From: Altmayer, Scott A [altmaysa@westinghouse.com]
Sent: Tuesday, July 06, 2010 8:48 PM
To: Buckberg, Perry
Cc: Sanders, Mitchell P.; Stipanovich, Steven M; Ritterbusch, Stanley E; Loza, Paul G.
Subject: OI-914-03 R3A
Attachments: OI-SRP9 1 4-SBPB-03 R3 draft mps 7-5-10-scott.doc

AP1000 TECHNICAL REPORT REVIEW

Response to Request For Additional Information (RAI)

RAI Response Number: OI-SRP9.1.4-SBPA-03
Revision: 23A (7/6/10)

Revise DCD Figure 9.1-4 to add the location of the new fuel elevator and the "northing" orientation arrow as shown below.

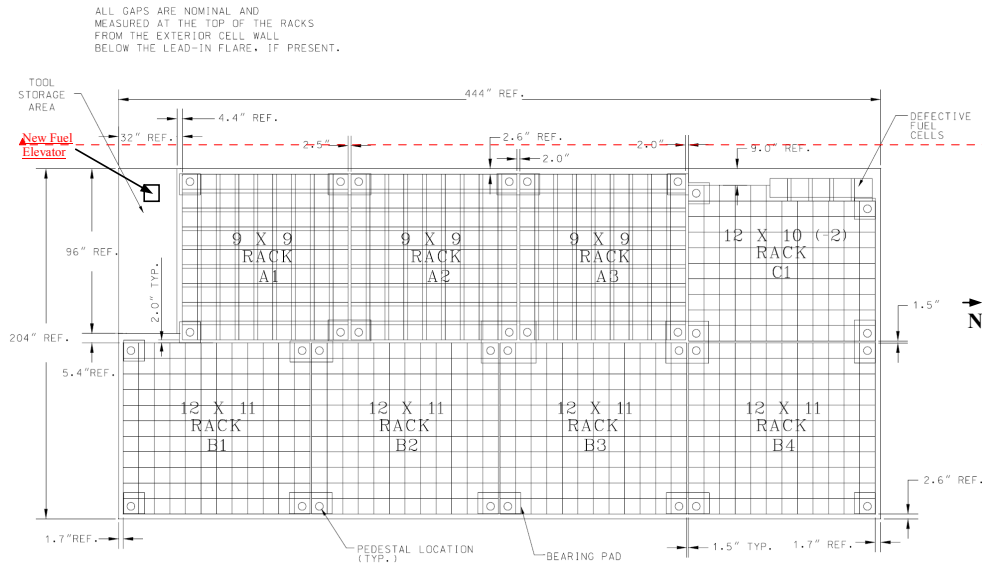
1. There are no provisions in the DCD that prevent the use of the non-single failure proof hoist from handling new fuel above the operating floor. How does Westinghouse intend to address this issue?
2. A specific location of the new fuel elevator shall be provided (with sketch in the response). A DCD change to include either a detailed description of the location or a drawing of the location shall be provided in this response.
3. Clarify whether any new fuel is capable of passing over spent fuel, and describe preventative measures (interlocks) included to restrict travel over spent fuel. A DCD change shall include a description of the interlock(s).

The new fuel elevator fuel carrier is located in the tool storage area of the spent fuel pool. The fuel carrier centerline is approximately 24 inches south of the centerline of the southern most row of storage rack A1. See revised Figure 9.1-4 in the attached DCD markup for general placement.
